DDN-AC-10

DATE:	02 August 2022	CONFIDENTIALITY:	Public
SUBJECT:	Condition 6 - Fixed Plant Noise Emissions (Response to EHO)		
PROJECT:	Spa @ KSTH	AUTHOR:	Jamie Murray
CHECKED:	Mark Hinds	APPROVED:	Mark Hinds

Figure 1 - Proposed louvres

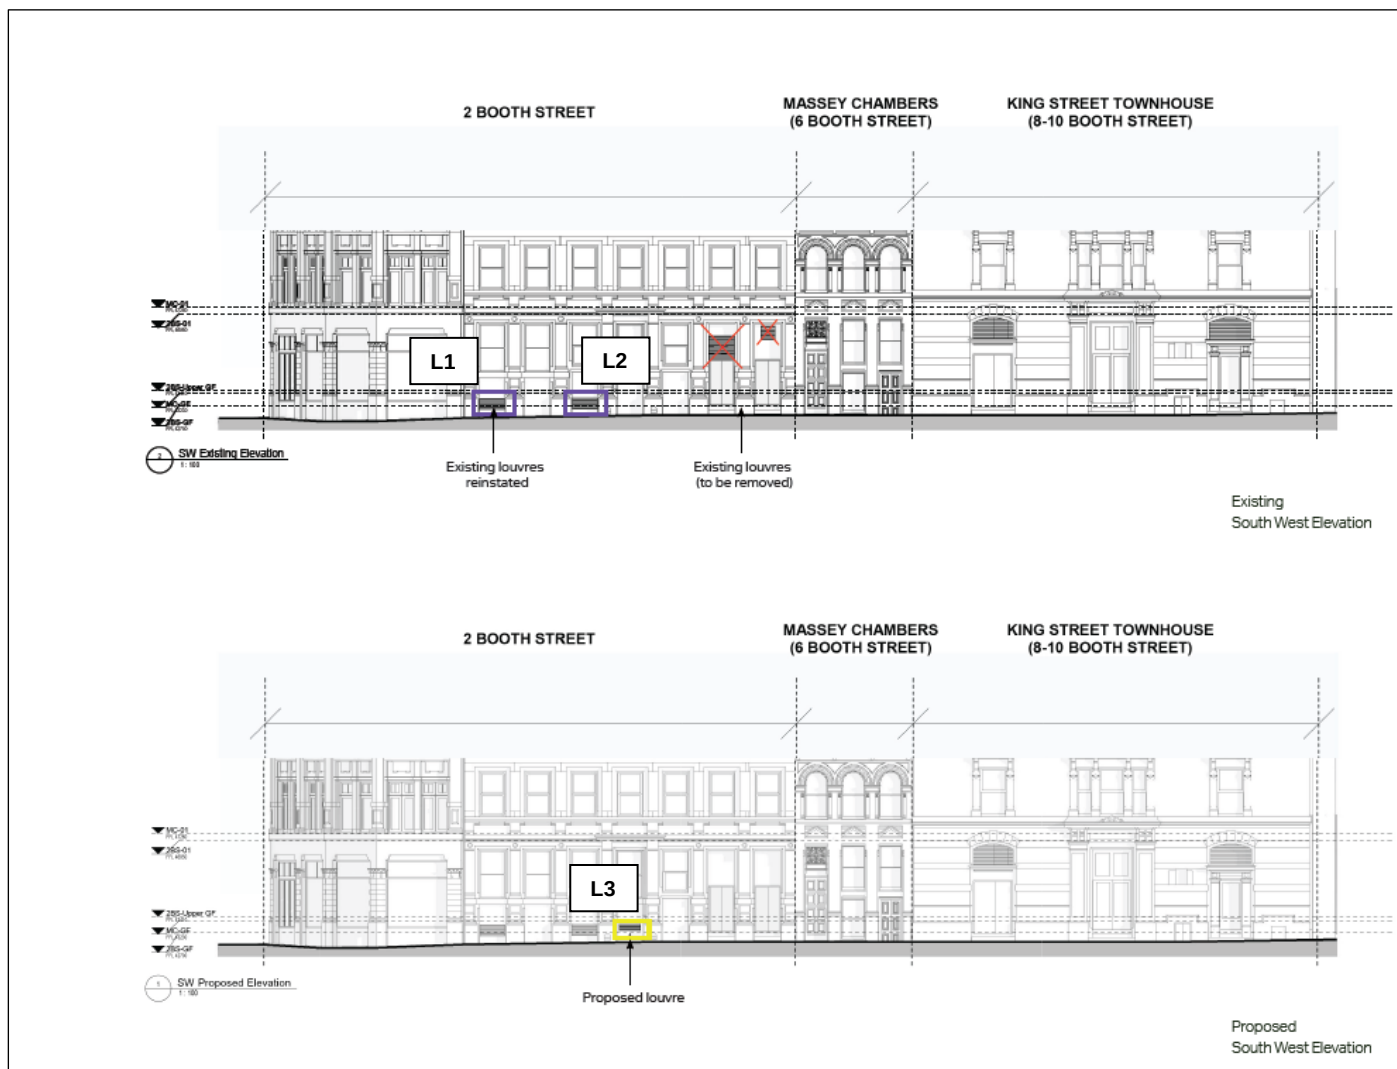
"I am still just a little concerned regarding noise from the louvres. The response states that the louvres are to allow "combustion air and heat rejection from the hot water plant area by natural means". Surely this rejection must be by some form of forced means or by a fan? Any air pushing over the blades of the fan or air passing through the louvres at speed will create some noise? Is the rejected air being emitted at force or mechanical assistance? Maybe the agent could give some more information regarding this air rejection and a more detailed description and can this be added to the validation testing scheme?"

No noisy equipment was shown to be served by these louvres as part of the Mechanical, Electrical & Plumbing (MEP) design and they were, therefore, discounted from the detailed assessment of noise emissions. This note has been prepared in response to the EHO question relating to noise from the louvres and it includes the results of a site investigation to establish the noise output (if any) from the louvres.

The design included the 3no louvres, which are highlighted below (L1 - L3).
